Monitoring Report – MY2
FINAL VERSION
Lake Wendell Mitigation Project
Calendar Year of Data Collection: 2019

NCDEQ DMS Project Identification # 97081
NCDEQ DMS Contract # 6826
Neuse River Basin (Cataloging Unit 03020201)
USACE Action ID Number: SAW-2016-00876
NCDEQ DWR Project # 2016-0385
Johnston County, NC
Contracted Under RFP # 16-006477

RE: WLS Responses to NCDEQ DMS Review Comments for Task 8 Draft Monitoring Report Year 2 for the Lake Wendell Mitigation Project, NCDEQ DMS Full-Delivery Project ID #97081, Contract #6826, Neuse River Basin, Cataloging Unit 03020201, Johnston County, NC

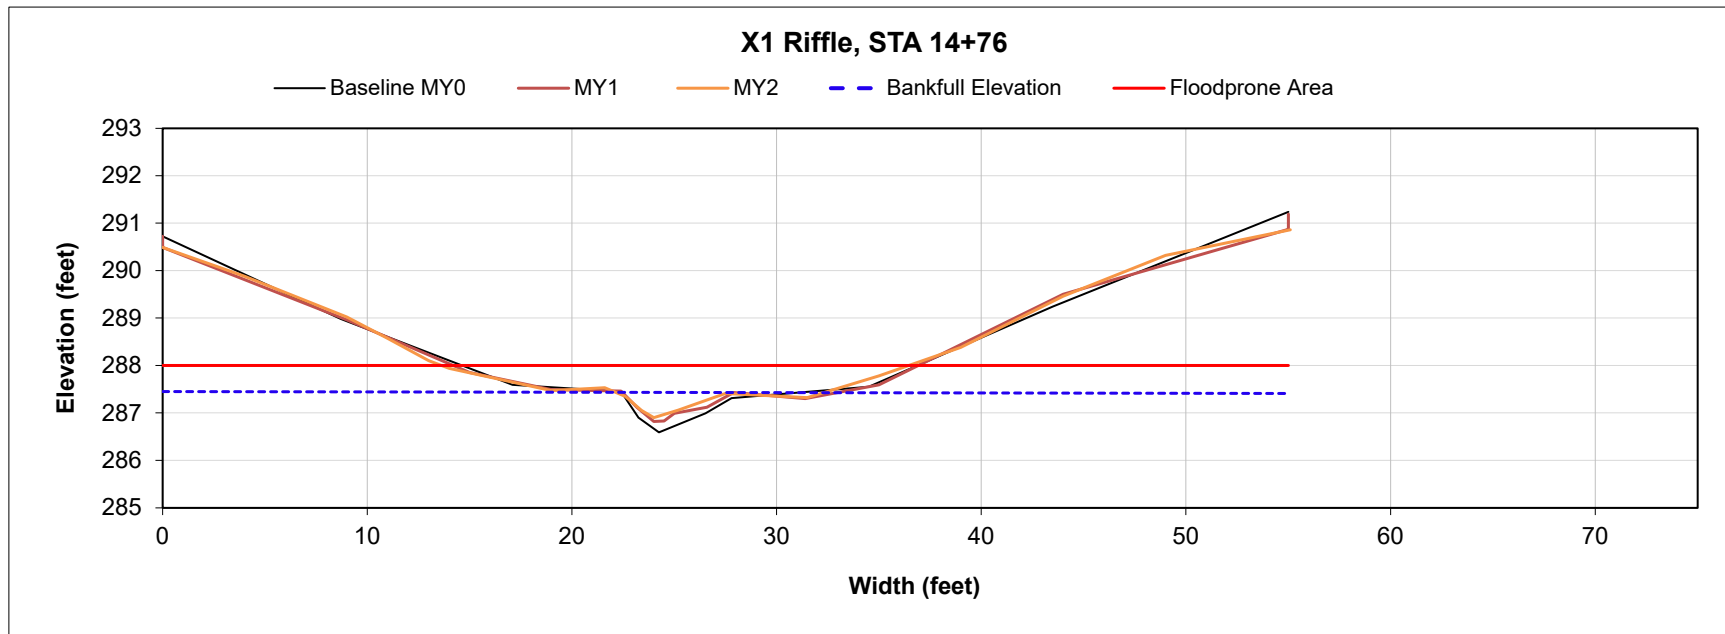
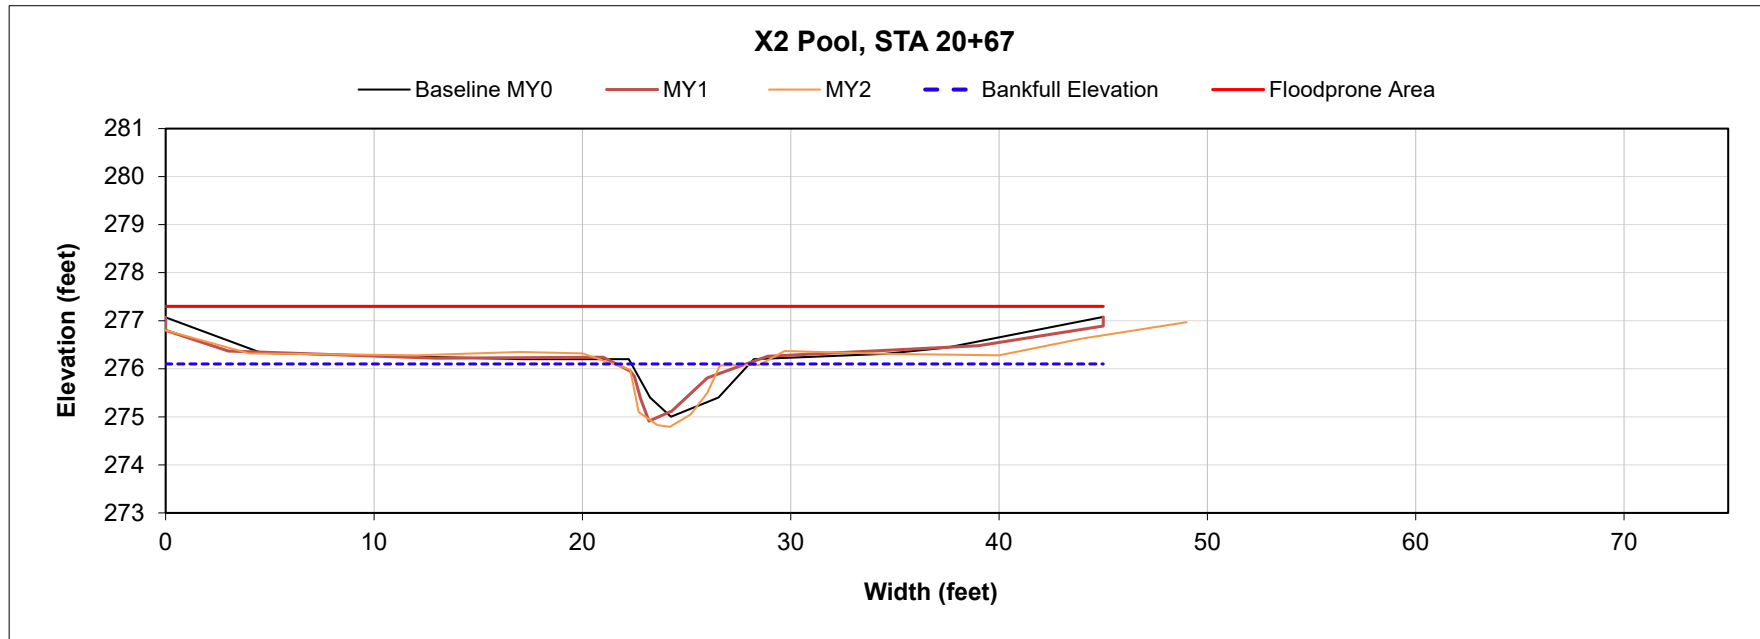
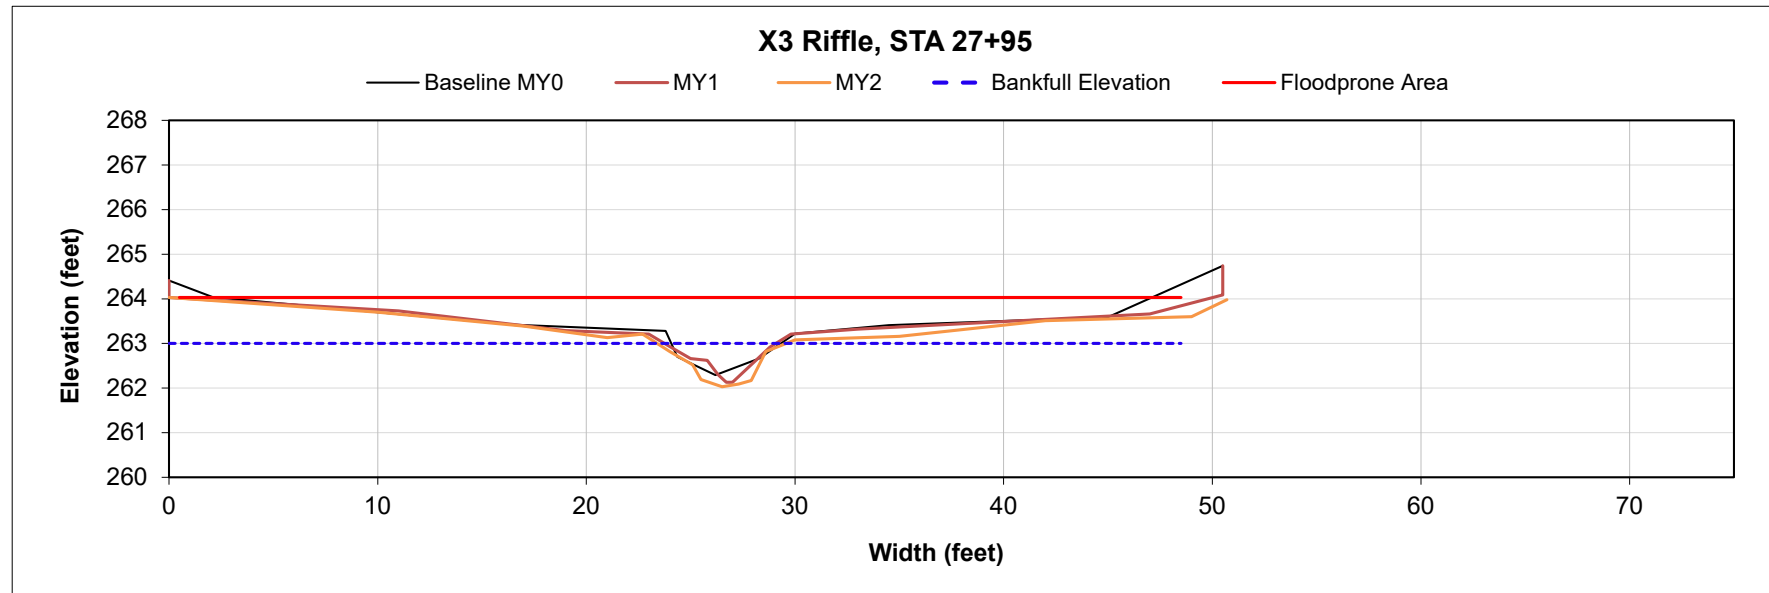
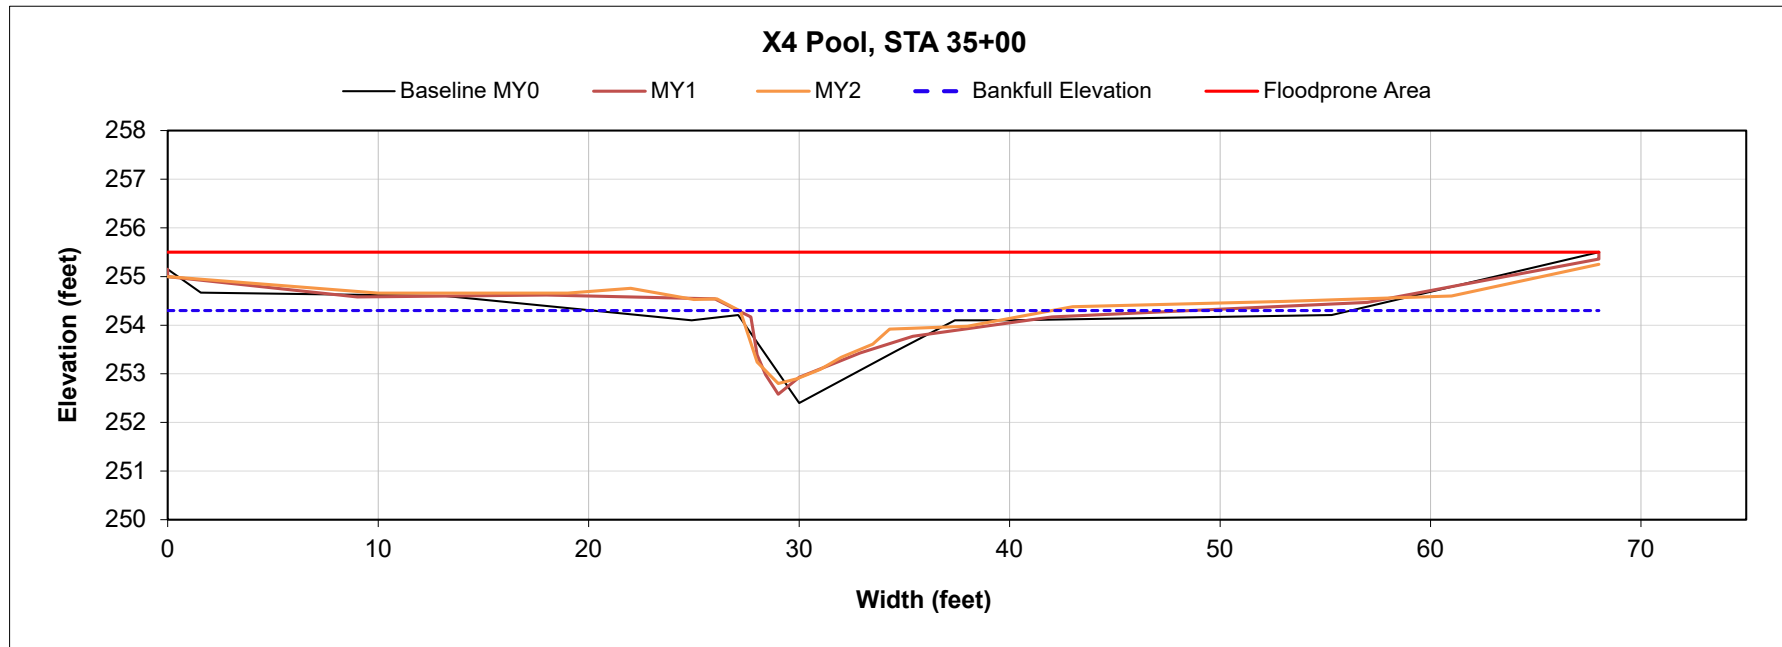
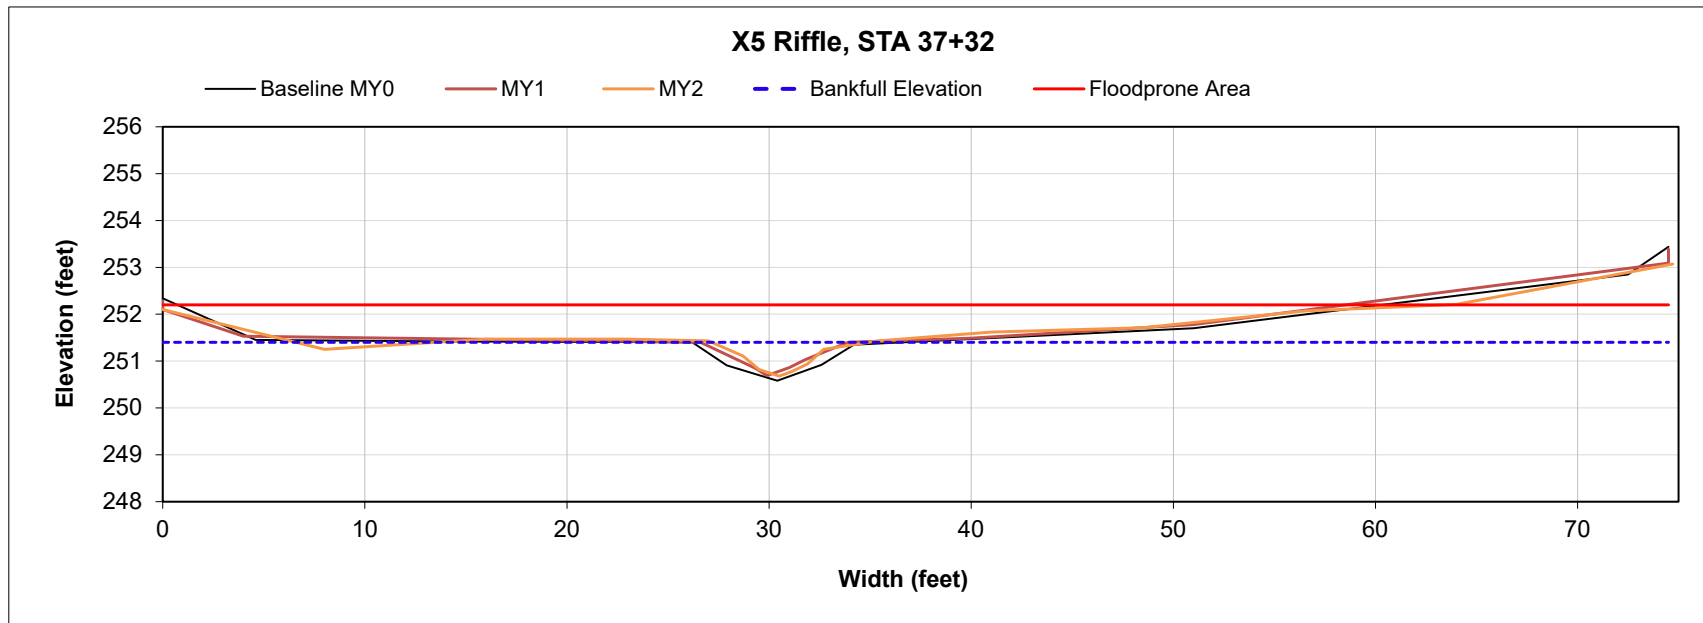
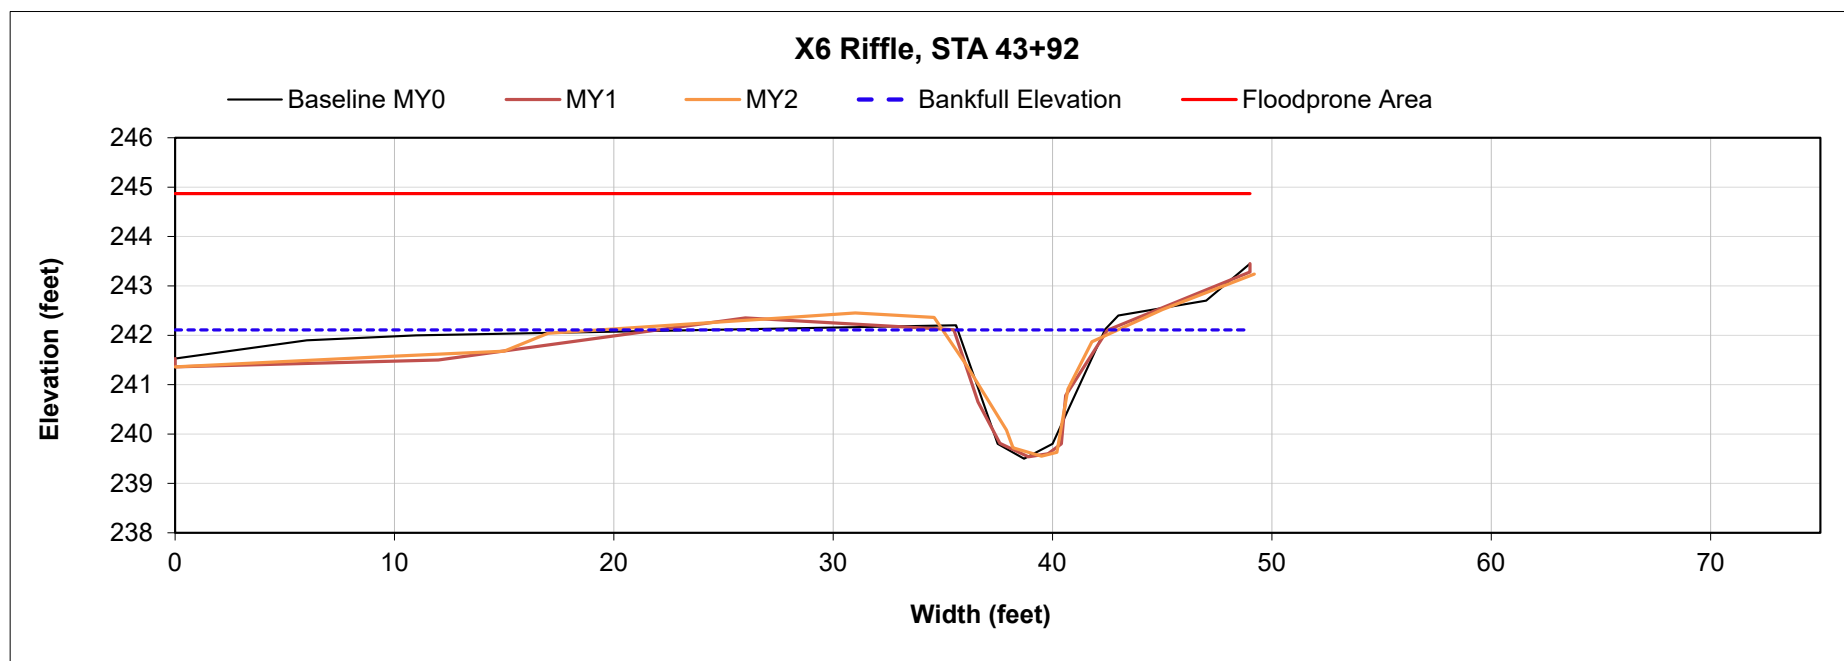
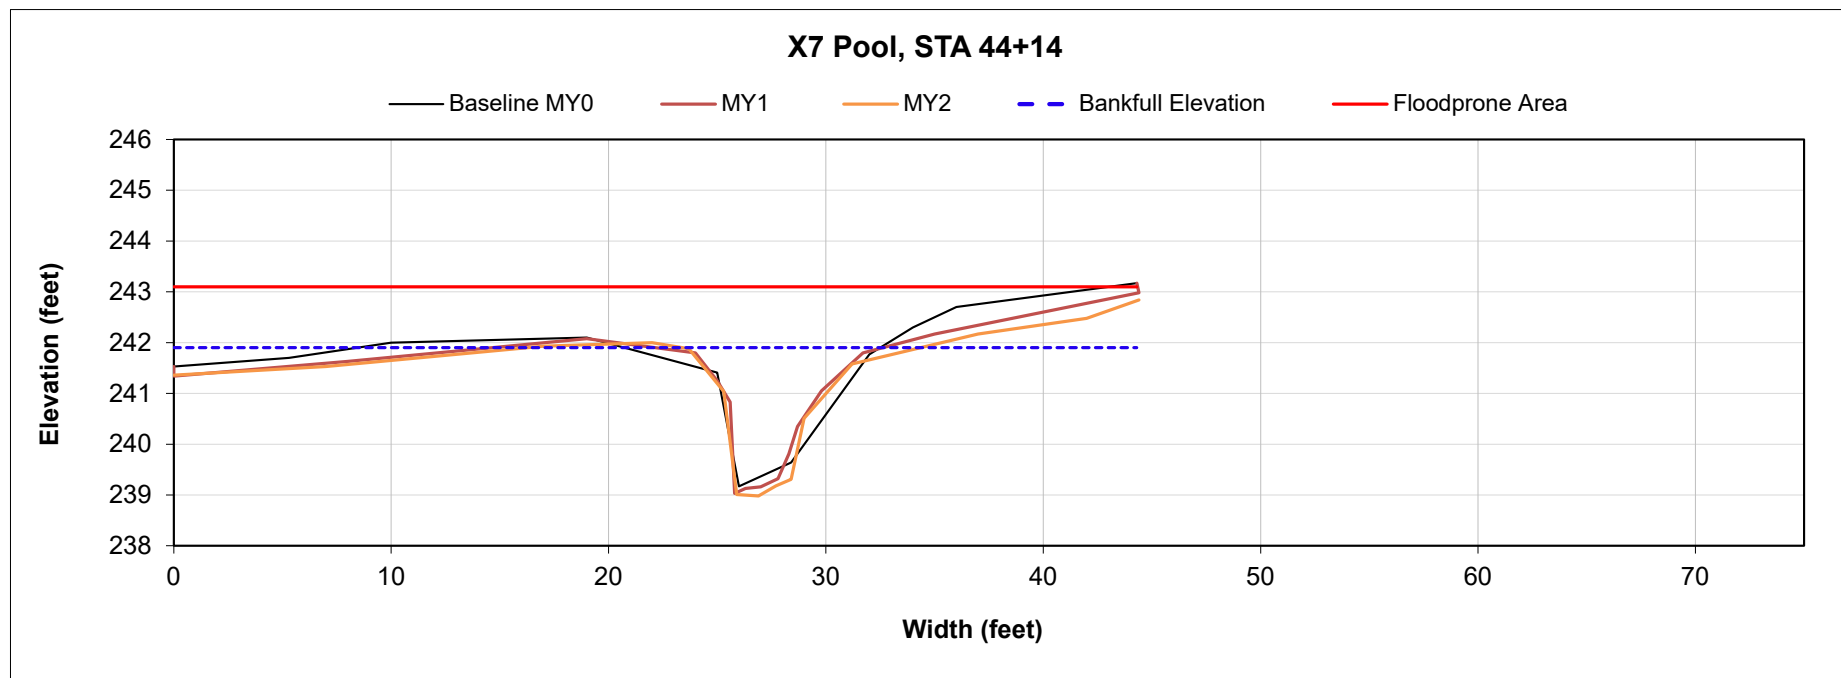
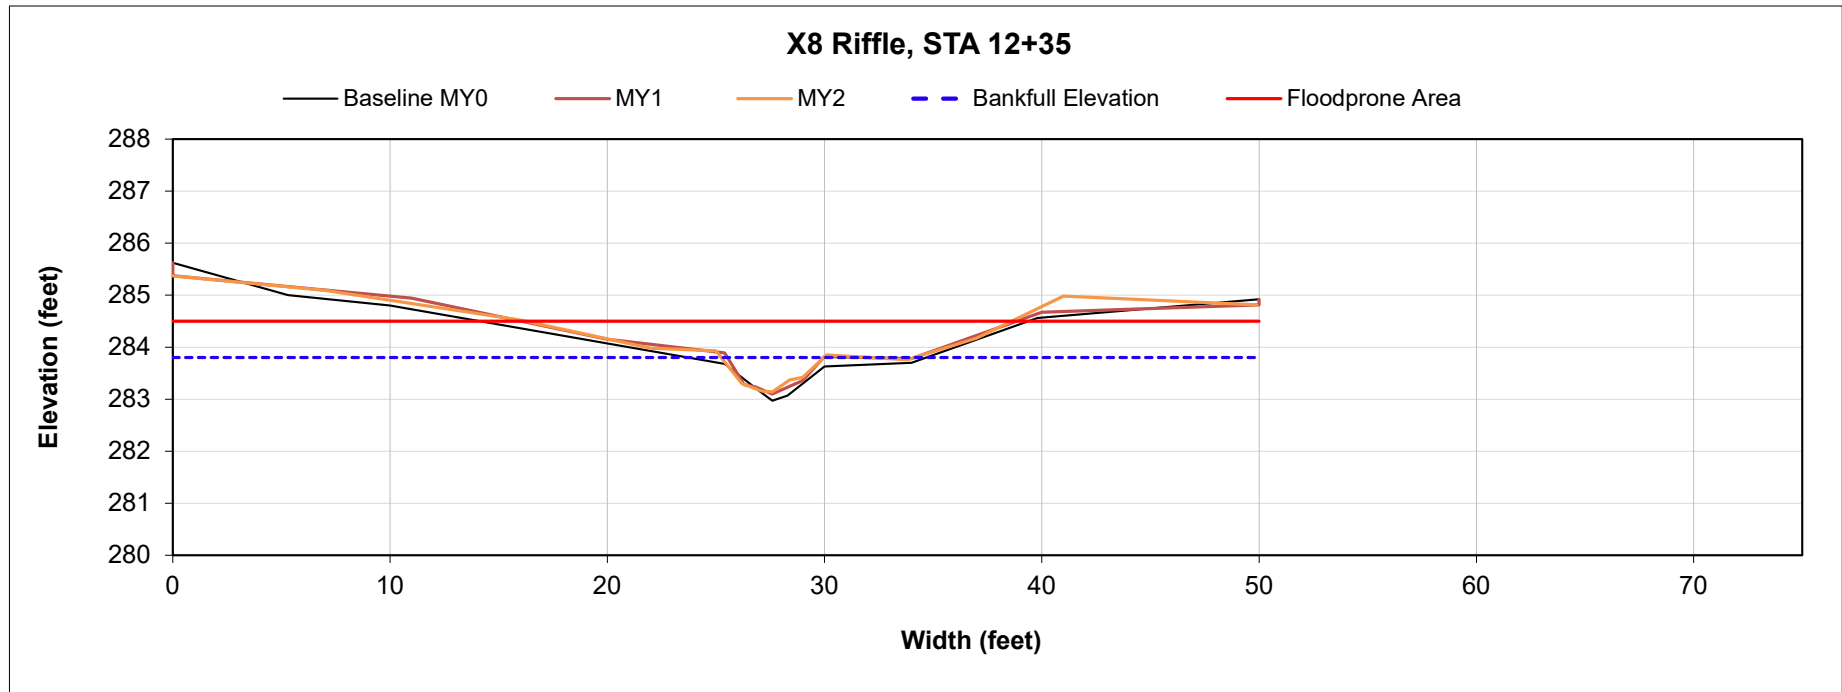
3. **DMS Comment: Check the % change BHR for all XS, especially 3, 5, and 8 (these should not be negative).** WLS Response: WLS has updated all BHR's to remove negative percentages.

4. **DMS Comment: Note the x and y axis on your stream cross sections varies in scale significantly. It may benefit your project to present all cross sections on a standard scale for comparison purposes for future reports.** WLS Response: WLS has updated the scales across all Lake Wendell cross sections to be consistent on the x and y axis.
